**PALO VERDE COMMUNITY COLLEGE  
NEEDLES CENTER (CLAYPOOL BUILDING)  
MEZZANINE PROJECT**

**BID NO. 2020-01**

**ADDENDUM NO. 1**

**October 23, 2020**

**A-203**

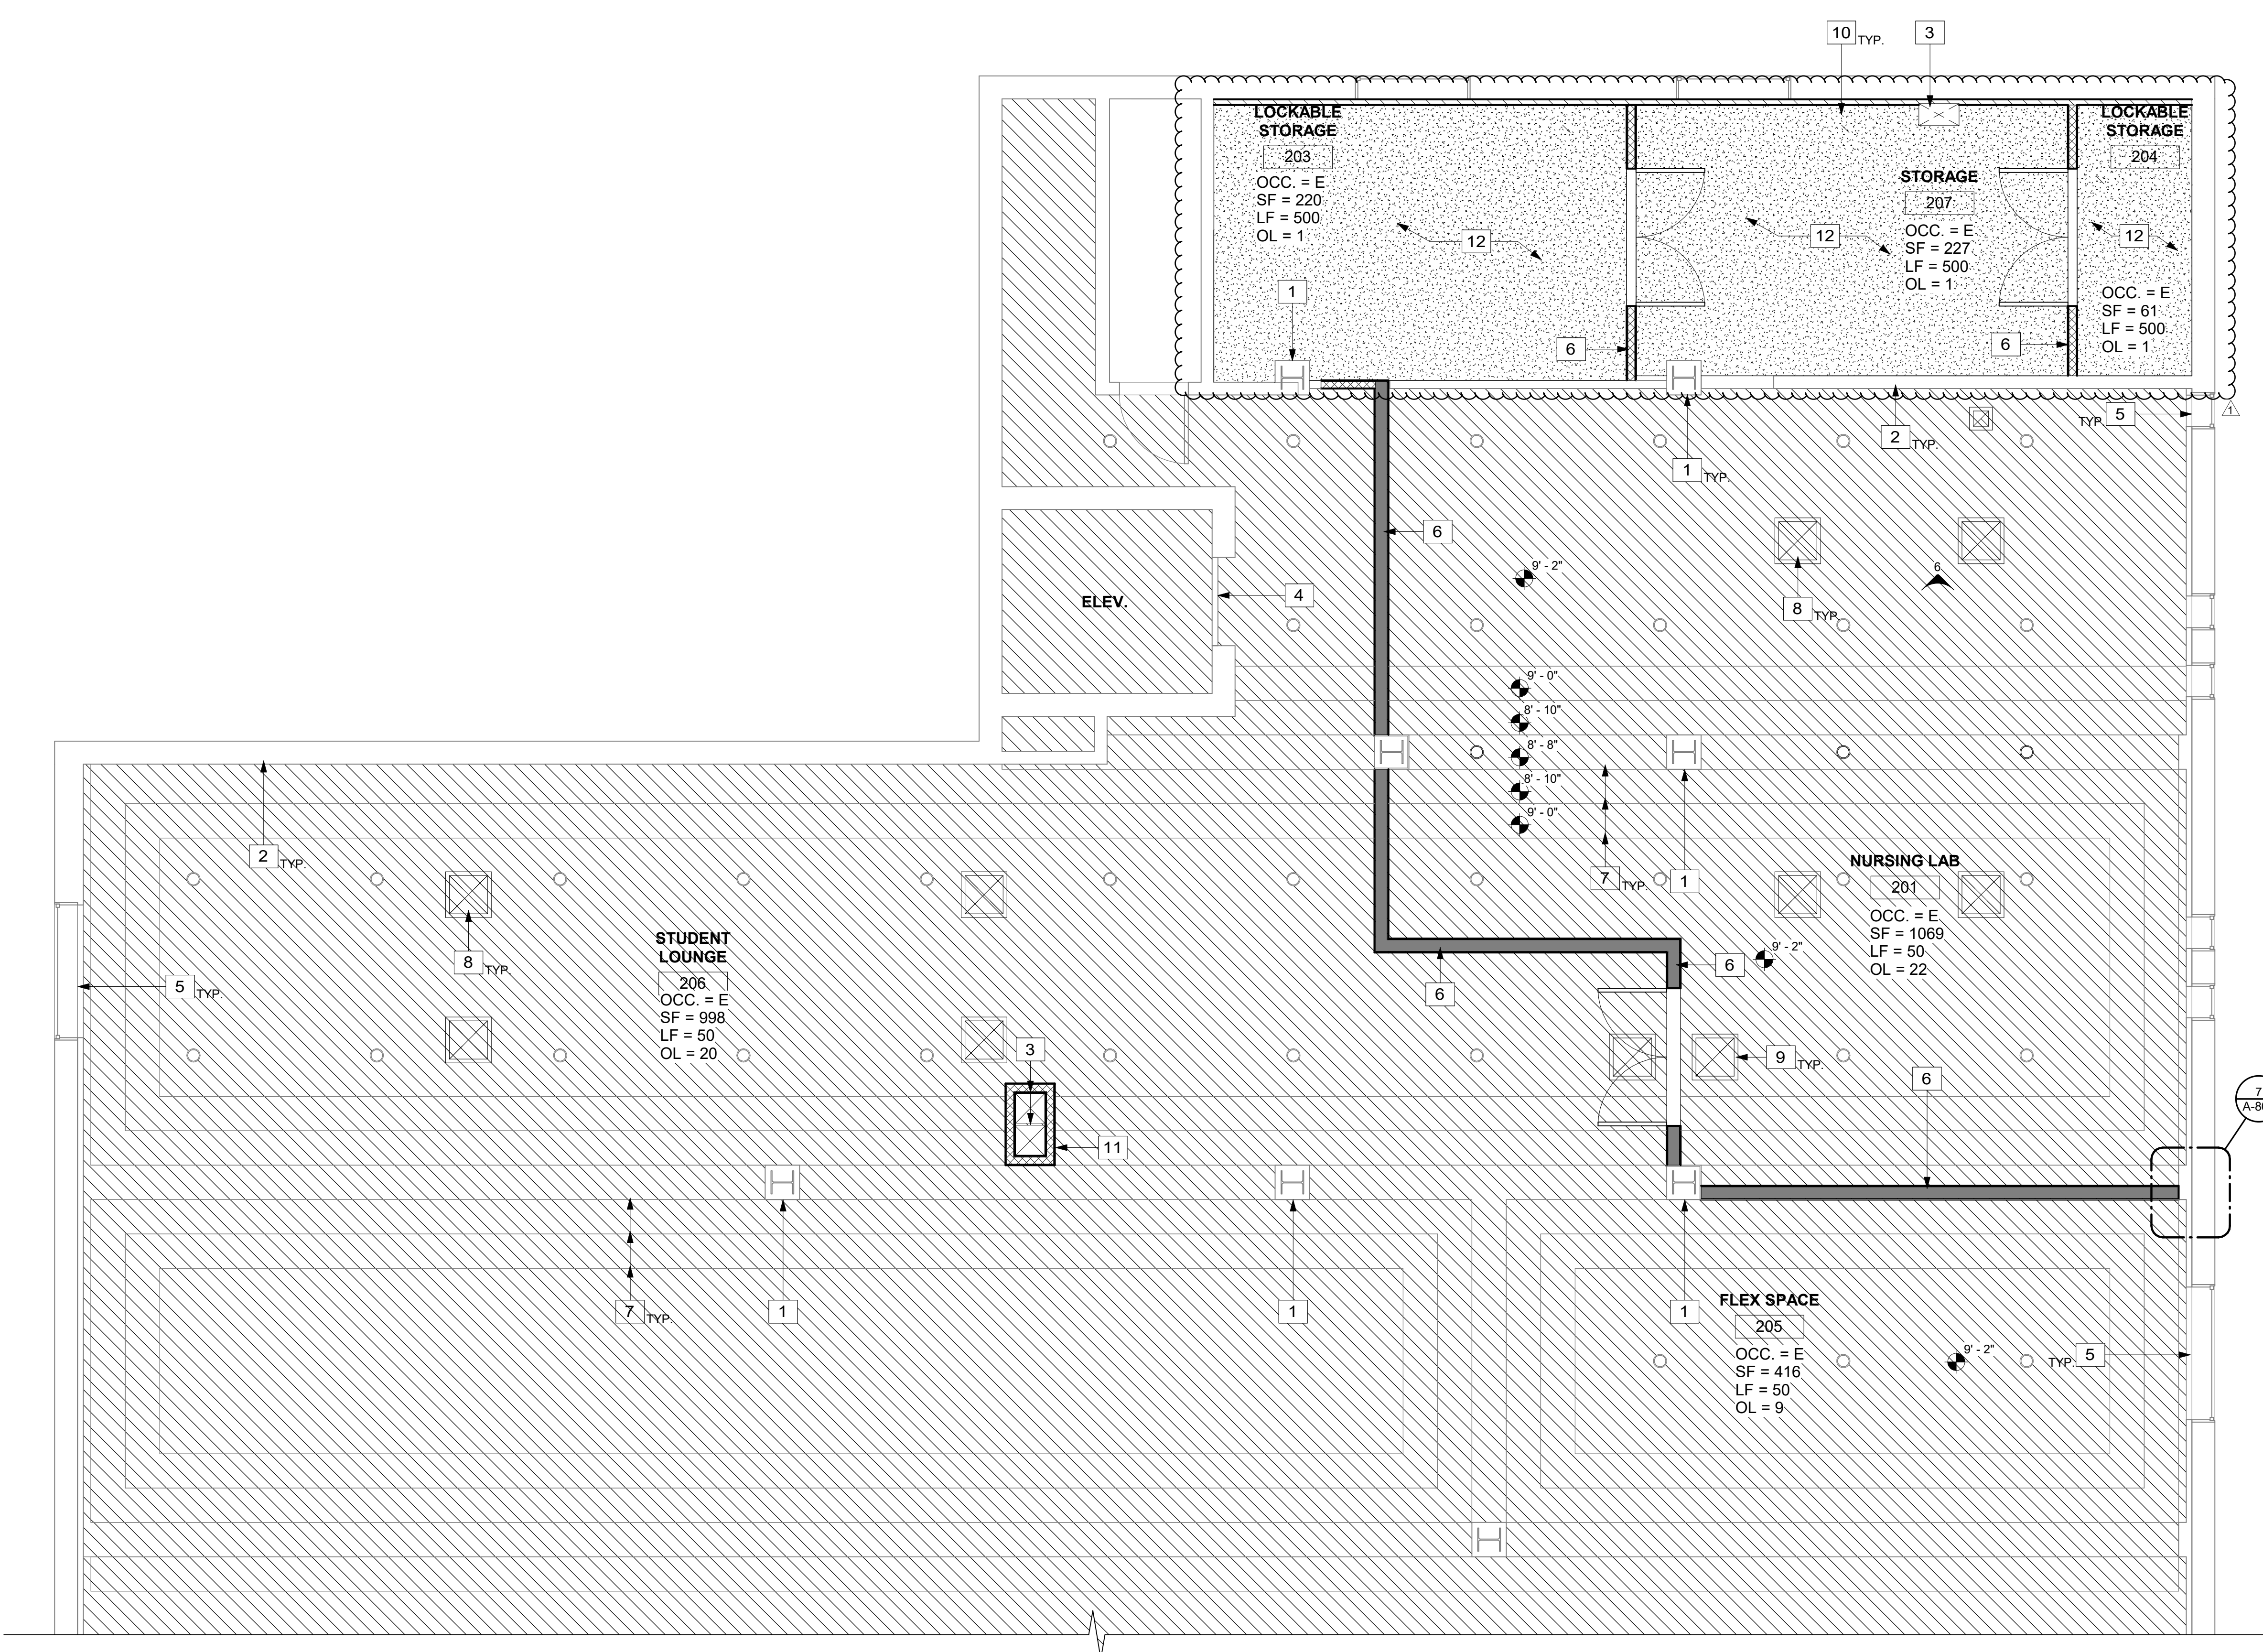
RFI 1 Question: Sheet A-203 does not show a call out for the ceiling for rooms #203, 204, and 207. Please advise.

RFI 1 Response: Rooms 203, 204 and 207 shall receive a new suspended gyp board ceiling. See revised Reflected Ceiling Plan, Sheet A-203.

**BUILT-IN BENCH DETAIL** 11  
1" = 1'-0"

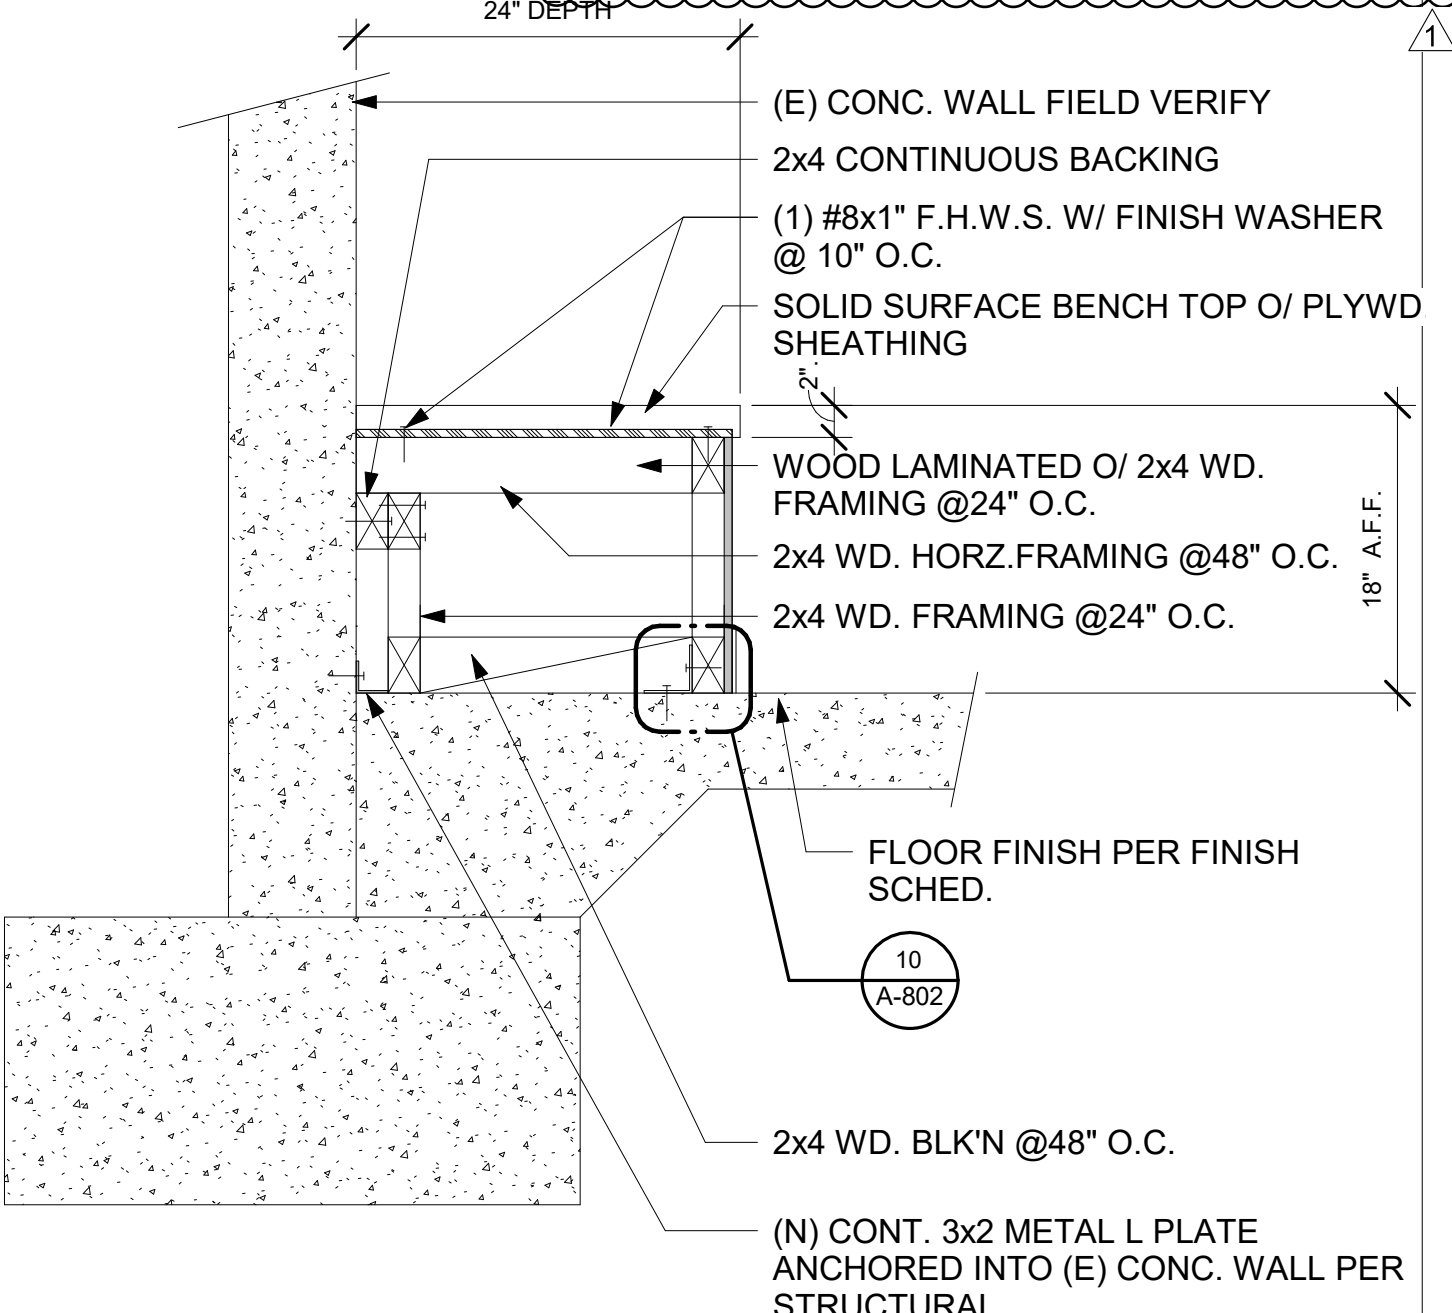
1. Sheet G-004: Detail #2, Accessible Restroom Path – Keynote at Men's RR has been revised from 2 to 1
2. Sheet A-201: Keynote #26 has been revised
3. Sheet A-201: Keynote #38 has been added
4. Sheet A-201: Keynote #39 has been added
5. Sheet A-201: A new built-in bench has been added to Room 206 Student Lounge
6. Sheet A-201: A new note has been added to patch the hole in the concrete floor
7. Sheet A-201: Note added to provide dust & pollution control during construction
8. Sheet A-203: Keynote #12 has been added and ceilings in Rooms 203, 204 & 207 are now indicated to have new suspended gyp board ceiling
9. Sheet A-802: Detail #10 has been added
10. Sheet A-802: Details #11 has been added
11. Sheet S1.0: New furring wall has been added to Rooms 203, 204 & 207
